**Variance requested: Reduce public road frontage from 75' to ~26' for Lot #2 (Flag Lot)**

**Lot Layout**  
**A&R Engineering Inc.**  
 2100 Marietta Road, Suite 100  
 Marietta, GA 30067  
 Tel: (770) 426-4400

**APPLICANT:** Lily Estates, LLC **PETITION No.:** V-65  
**PHONE:** 770-690-9255 **DATE OF HEARING:** 09-12-12  
**REPRESENTATIVE:** Abdul K. Amer **PRESENT ZONING:** R-20  
**PHONE:** 404-610-1431 **LAND LOT(S):** 982  
**TITLEHOLDER:** Lily Estates, LLC **DISTRICT:** 16  
**PROPERTY LOCATION:** On the east side of Old Canton Road, south of Roswell Road **SIZE OF TRACT:** 1.089 acres  
**COMMISSION DISTRICT:** 2  
(1060 Old Canton Road).

**TYPE OF VARIANCE:** 1) Waive the minimum lot width at front setback from the required 75 feet to 26 feet in order to allow for subdivision of property to create second lot; and 2) waive the minimum public road frontage from the required 75 feet to 26 feet in order to allow for subdivision of property to create second lot.

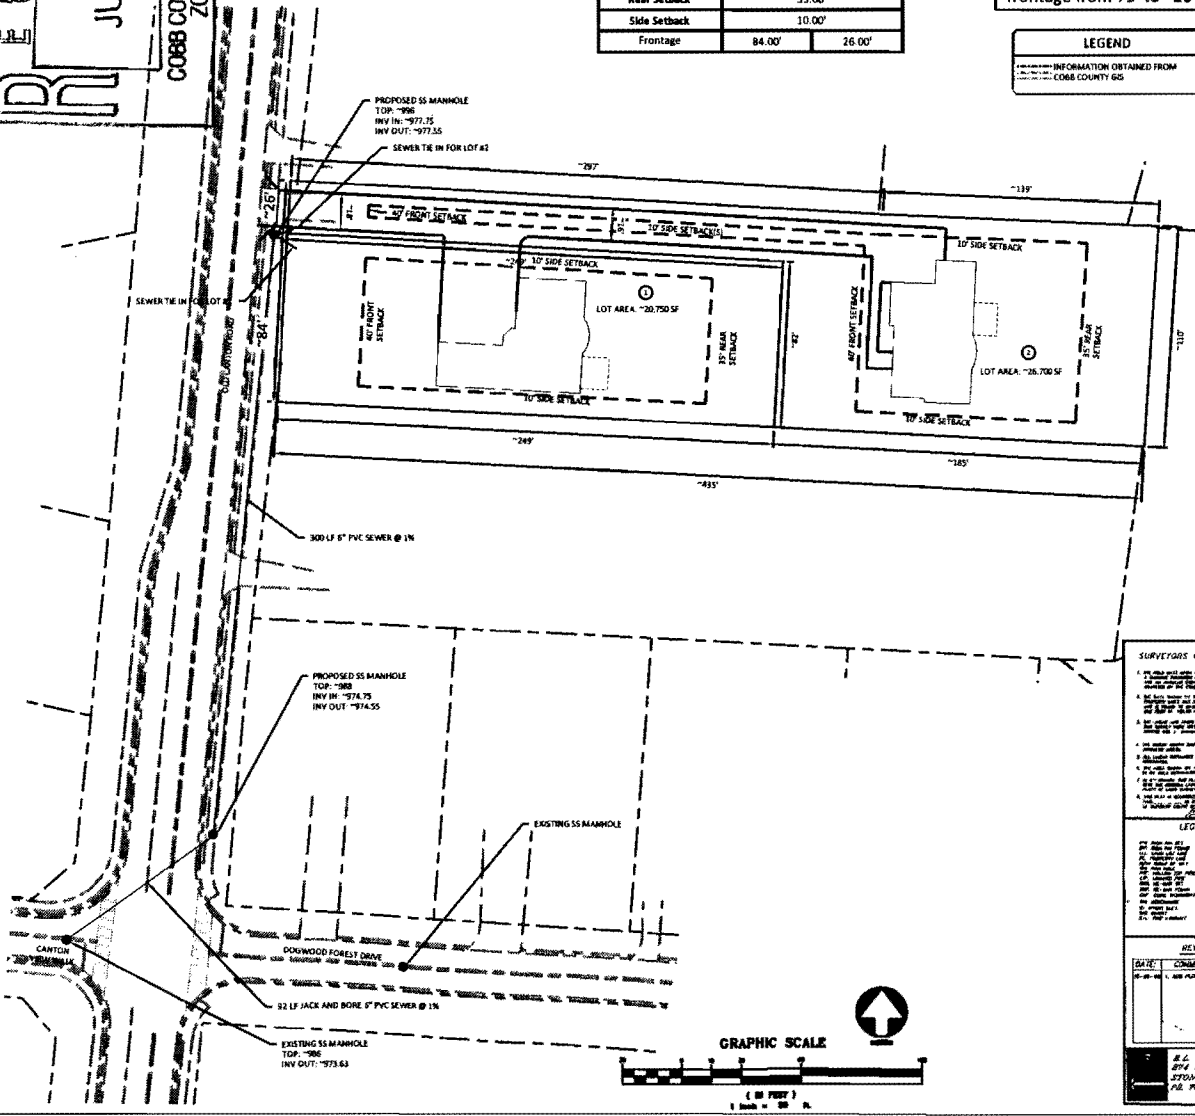
**TRAFFIC:** Recommend one shared driveway for the proposed subdivided lots.

**SITE PLAN REVIEW:** If this variance request is approved, a lot split plat must be recorded. The surveyor must submit the plat to the Site Plan Review Section, Community Development Agency for review and approval prior to recording. Call 770-528-2147.

**STORMWATER MANAGEMENT:** The proposed lot split will meet minimum zoning lot size and not exceed the maximum impervious coverage limitation. No adverse stormwater management issues are anticipated.

**Fire Apparatus access shall meet the following:**

- Driveway must have a minimum 12 feet driving surface width (CCDS 402.07.01) with minimum 25 feet inside turning radius.
- Driveway must have a minimum 12 feet driving surface width (CCDS 402.07.01) with minimum 25 feet inside turning radius.

- Fully developed landscaping shall be at least 7 feet 0 inches from center of drive (14 feet clear width) and 13 feet 6 inches vertical clearance.
- Maximum grade shall not exceed 18%, angle of departure shall not exceed 8.5%.

- Driveway must extend within 150 feet of the most remote portion of the structure.
- Driveway is limited to 1000 feet maximum from roadway unless an approved turn-around is provided

- Hydrant location within 500 feet of the most remote portion of the structure\*
- Fire Flow Test from closest existing hydrant shall be provided meeting the minimum\*  
(Required Flow: 1000 gpm @ 20 psi)
